**CITY OF PLATTSBURGH - DRI
DOWNTOWN GRANT PROGRAM - PROPOSED FARMERS MARKET RE-BID**

**SECTION 00 9112
ADDENDUM NUMBER 2**

1.02 PROJECT: CITY OF PLATTSBURGH - DRI DOWNTOWN GRANT PROGRAM PROPOSED FARMERS MARKET – RE-BID

A101

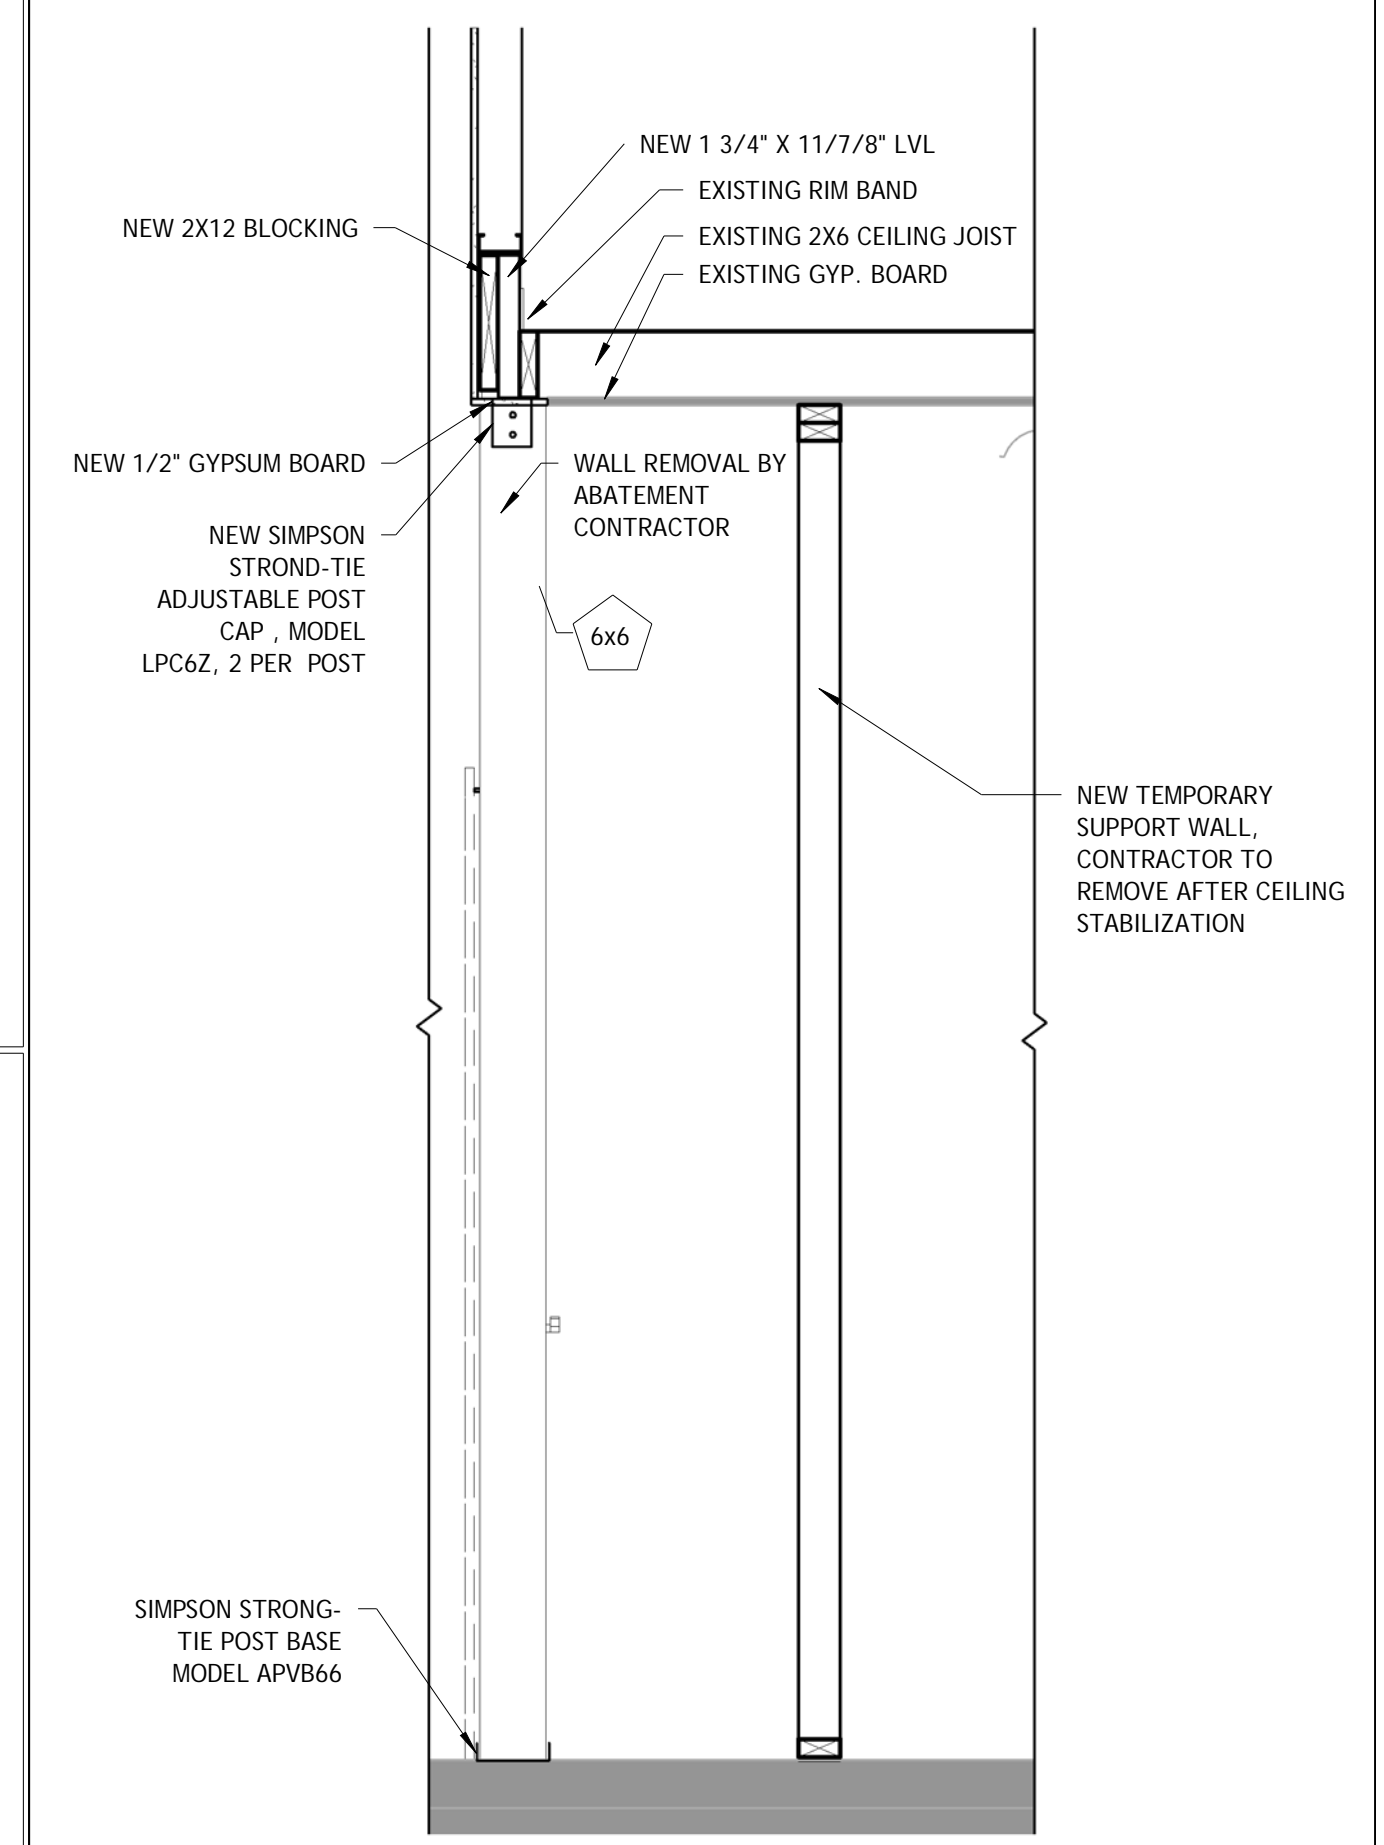
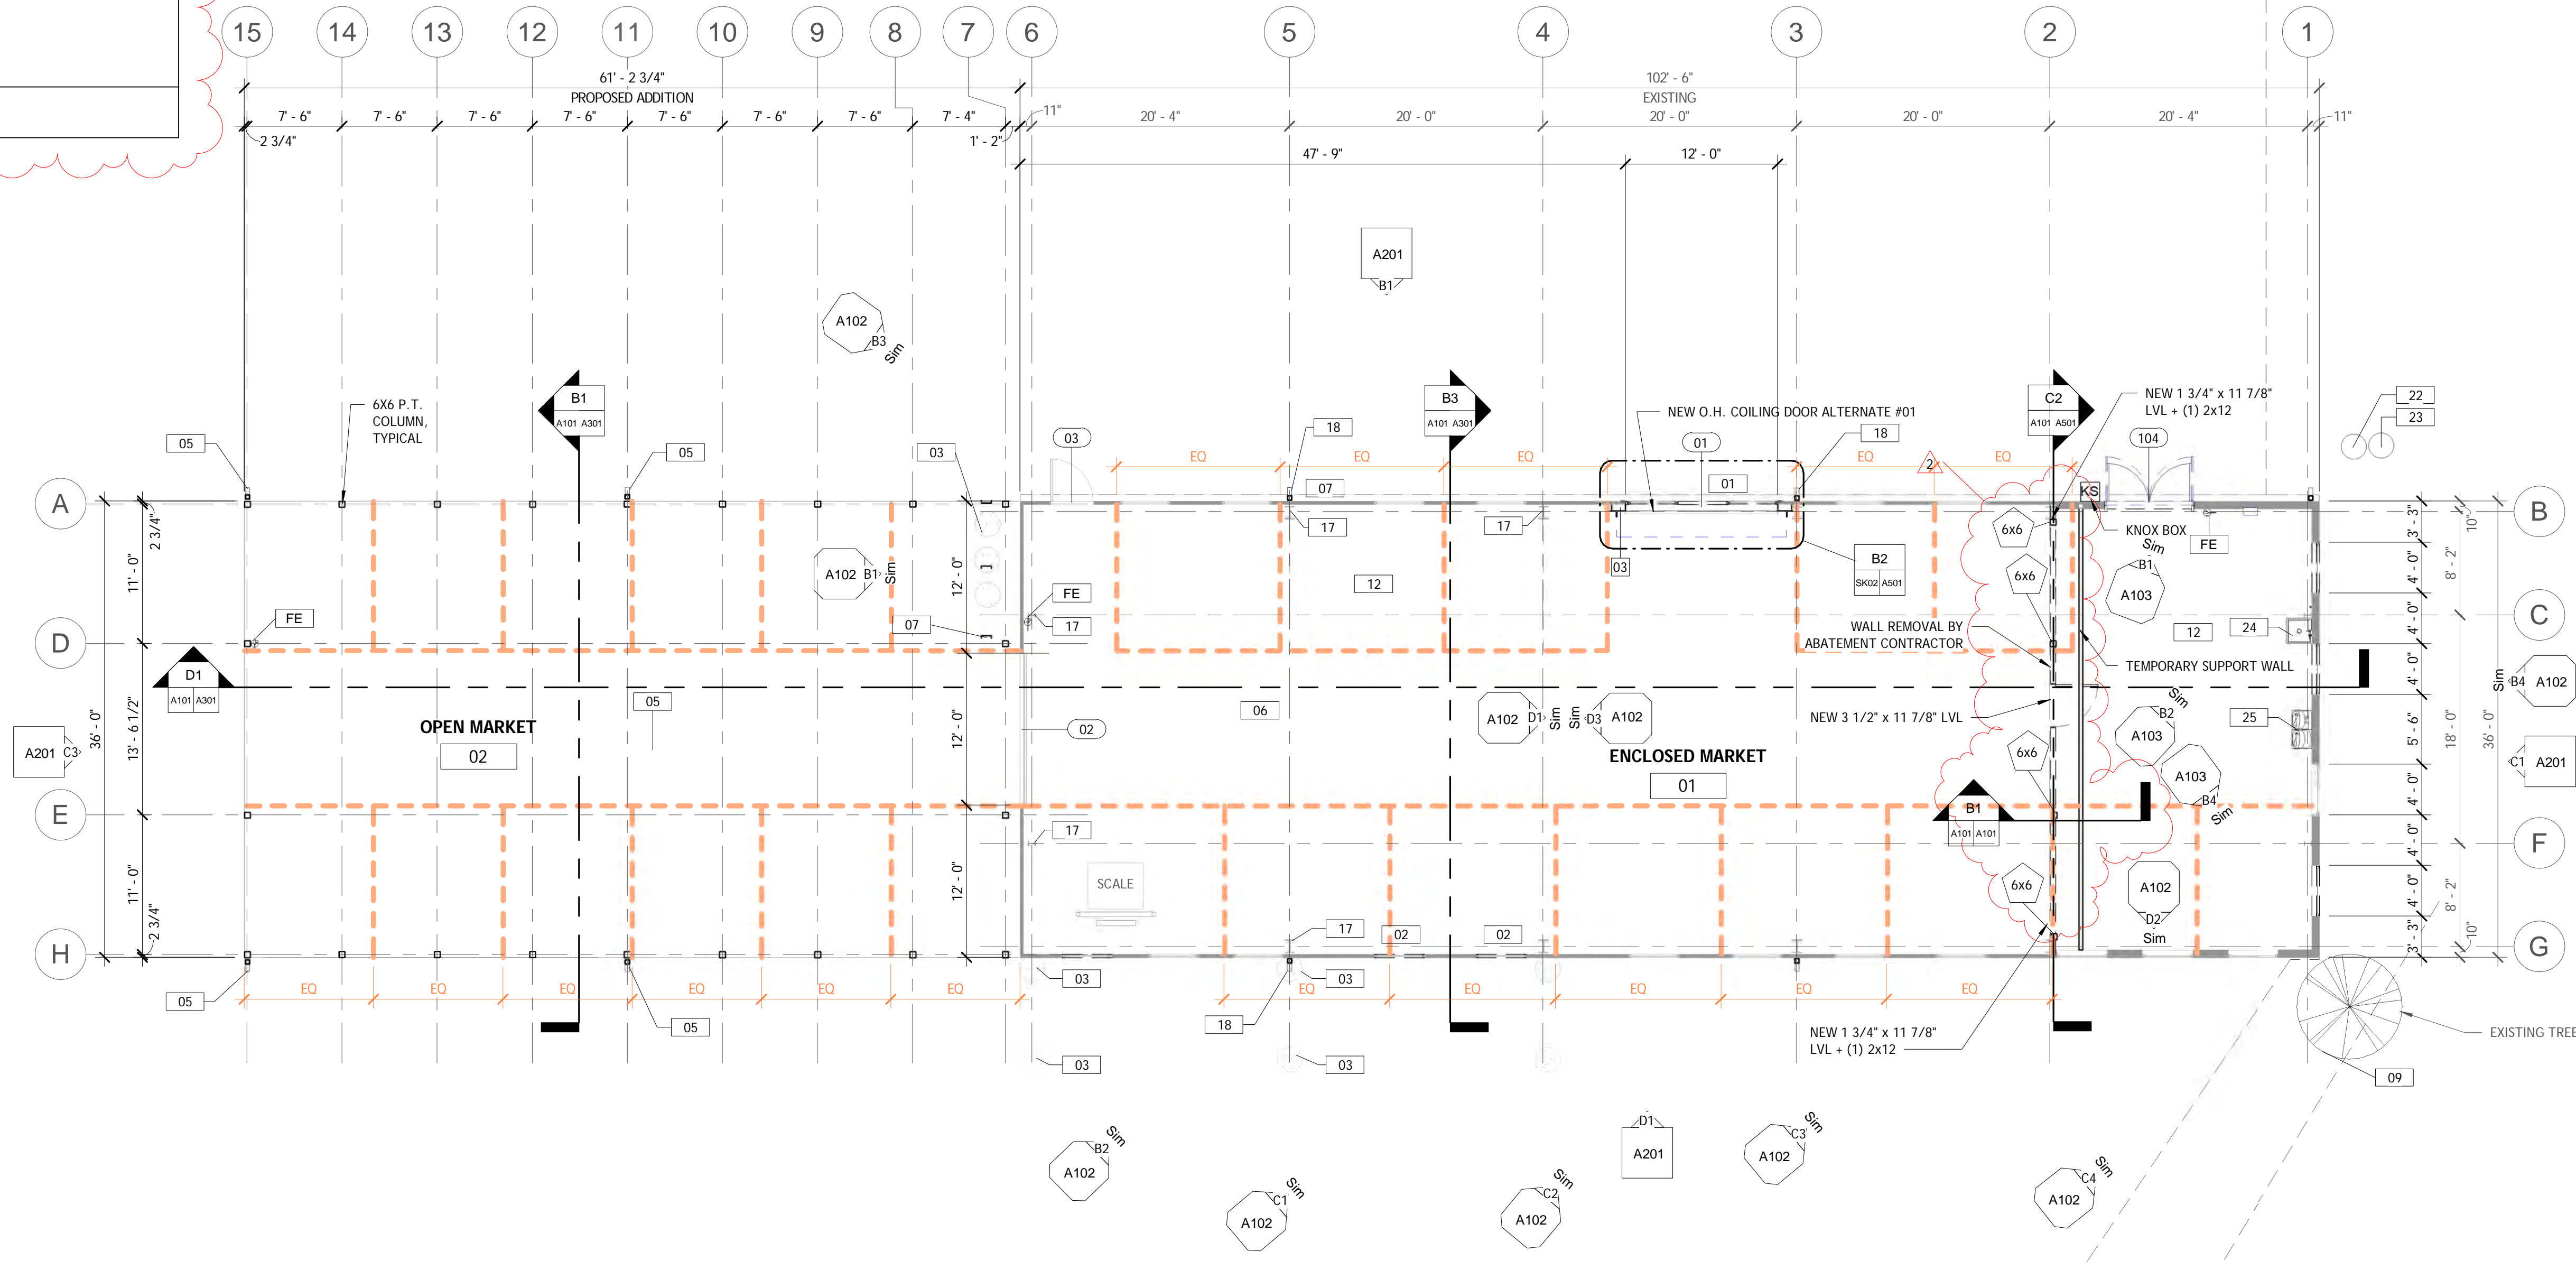
A. **RE-ISSUE** – Drawing A101, Floor Plan. **ADD** Support Beam Section B1 and information in Floor Plan D1 regarding requirements for a temporary support wall to support the existing ceiling during existing wall removal and permanent posts and beams for support of the ceiling structure after existing wall removal by attachment of the existing rim band to the new lvl's. Provide additional blocking and fasteners as required. Revisions denoted by revision symbol #2.
